Parts & Accessories Bulletin

PAB #387

XL 883 HORN KIT P/N 69014-88 INSTRUCTION SHEET CORRECTION

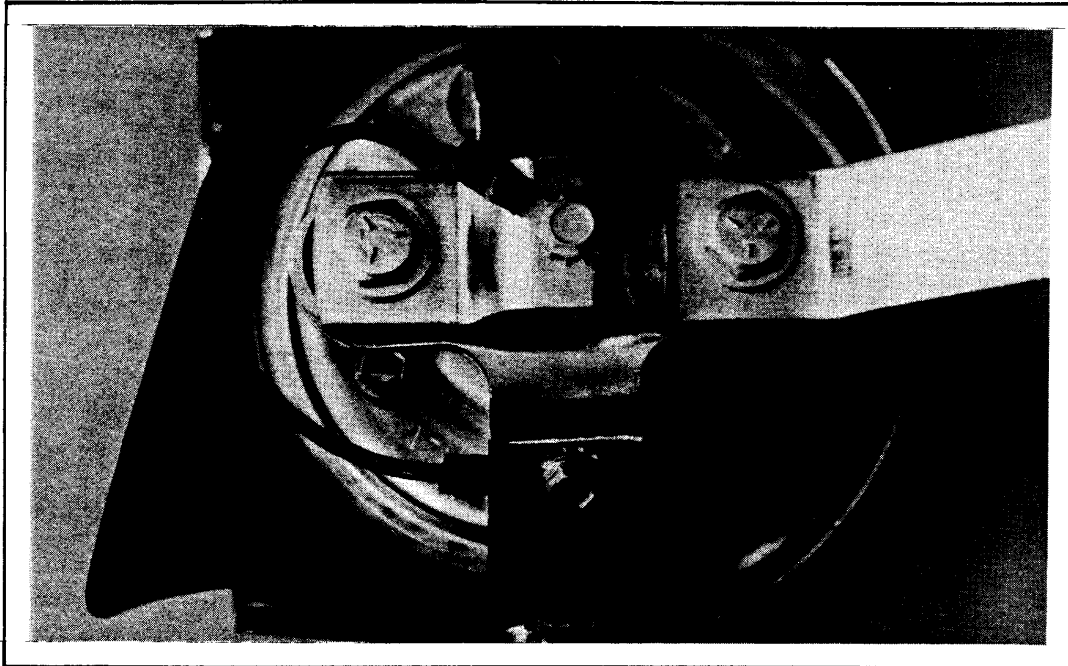
The instruction sheet supplied with this kit is incorrect.

The correct routing of the ground wire (step #4) is from the horn mounting bracket to the back side of the chrome horn cover. Please refer to the photo for correct installation.
